Taylor Creek Culvert Replacement

Meeting Summary

August 1, 2019

Schematic Design

Figure 1: Updated design proposal

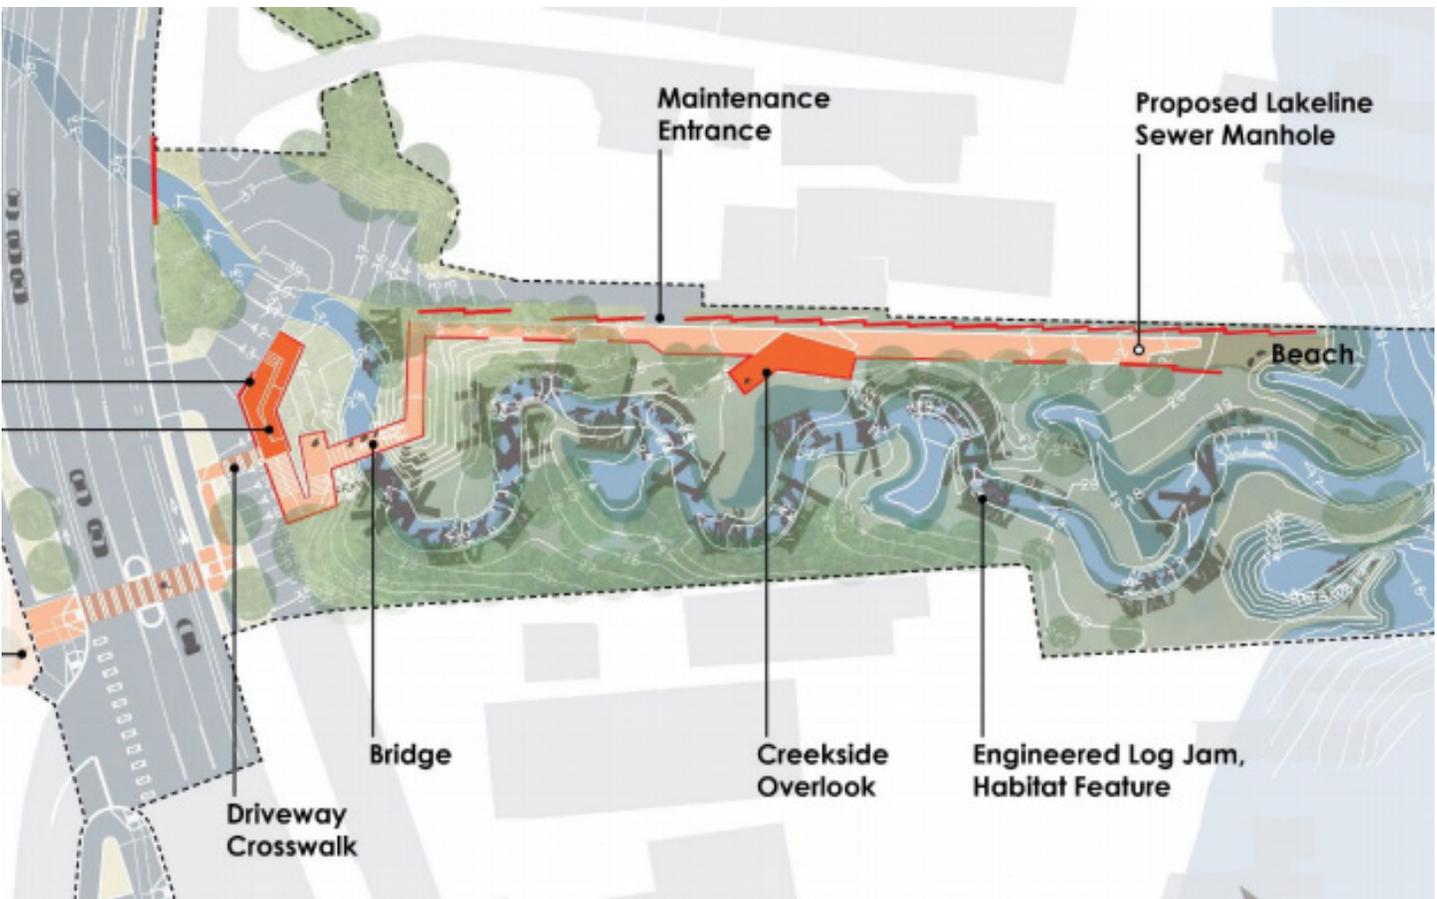
The SDC remains concerned with pedestrian crossing of Rainier Ave S between Lake Ridge Park and the new habitat restoration area. Although the Commission thought the proposed gathering space on the south side of Rainier Ave S would help lead pedestrians to the crosswalk, they are still concerned with the safety of pedestrians crossing the street given the curvature of the roadway and vehicular speed and strongly encouraged the project team to work with SDOT to create as safe of an environment as possible. Commissioners then discussed the proposed design of Rainier Ave S. Several commissioners are concerned with the length of vehicle turn lanes as well as the lack of drop off locations on the north side of the street. The Commission recommended the project team provide more information about the design and allocation of movements on Rainier Ave S as it relates to vehicular turning movements, length of turning lanes, and possibility to add drop off areas to increase safety.

The SDC then discussed circulation within the project site. Commissioners discussed circulation issues that also addressed issues around accessibility and equity. The Commission is concerned with the limited access to the northern portion of the site. Commissioners strongly encouraged the project team to reconsider providing an accessible parking space or ADA drop off point adjacent to the pathway along the northwestern edge of the site, so to not limit accessibility throughout the project site as well as limiting access for education programs such as viewing salmon habitat. The Commission then recommended the project team accommodate education programs in a way that is accessible to all.

The Commission appreciated the location of viewpoints throughout the site but recommended the project team reconsider the size and shape of each viewpoint. Specifically, commissioners recommended increasing the size of the ADA accessible viewpoints to better accommodate large groups for educational programs, while other viewpoints along the watershed could be resized to accommodate smaller groups, if it is not possible to provide ADA access to them. The SDC strongly recommended the project team provide cross sections through the site to better understand access and circulation.

1. Provide more information about Rainier Ave S as it relates to vehicular turning movements, length of turning lanes, the possibility to add drop off areas, and other approaches to increase safety for pedestrians.
2. Provide more information on how to accommodate educational programs in a way that is accessible to all
3. Reconsider the size of each viewpoint. Consider increasing the size of viewpoint nearest to Rainier Ave S for larger groups, in particular for those using the site for educational programs.
4. Continue to balance site improvements with habitat restoration in a way that does not impact the restoration goals of this project.
5. Provide cross sections through the site to better illustrate grade changes for accessibility between viewing areas
6. Provide more detail on art integration and interpretive elements
